Sicherheitsmitteilung
SM 202102

United Parachute Technologies, LLC. (UPT) Vector Schulgurtzeuge: SE 360-1 SE 360-2, SE 360-3, SE 361, SE 364, SE 364-1 vom Baujahr Mai 2013 bis Januar 2021.

VECTOR 3SE RESERVE PIN COVER FIELD MODIFICATION

VECTOR SE (STUDENT) RESERVE ISSUE

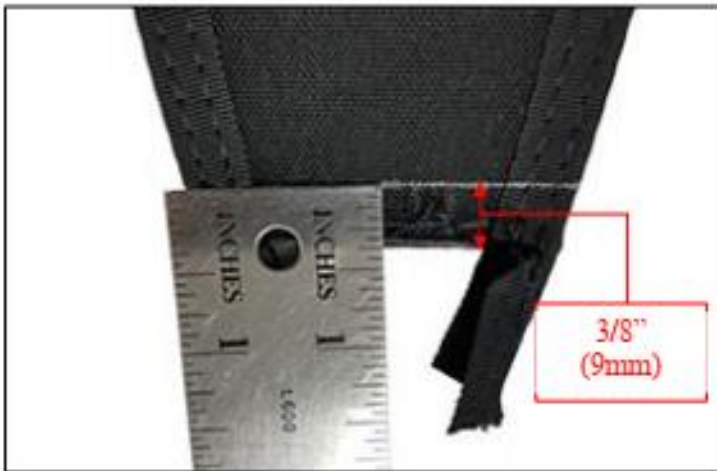
Identify the Reserve Pin Cover flap bottom "Tuck Tab".

Using either snips or a seam ripper, carefully unpick the binding tape stitching from the bottom edge of the flap.

Remove all stitching up to the folded corners.

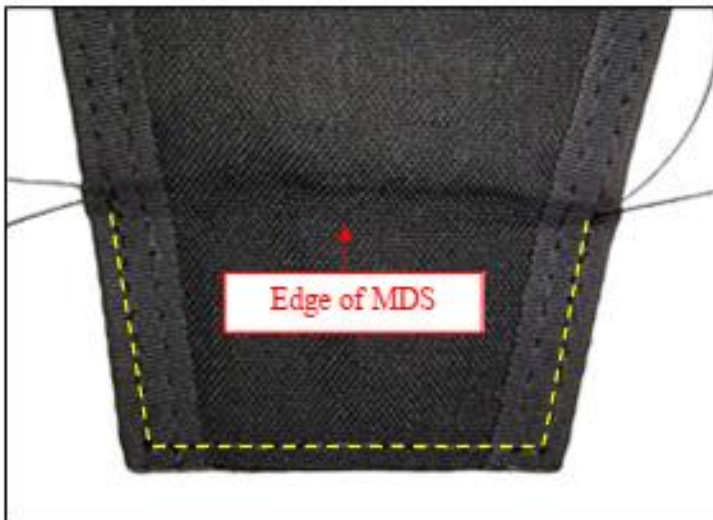
From the bottom edge of the flap, measure 3/8" (9mm) as shown and mark a line across the flap as shown.

Using heavy scissors, carefully cut and remove the end of the tuck tab.

The Bottom tuck tab is trimmed back 3/8" (9mm)
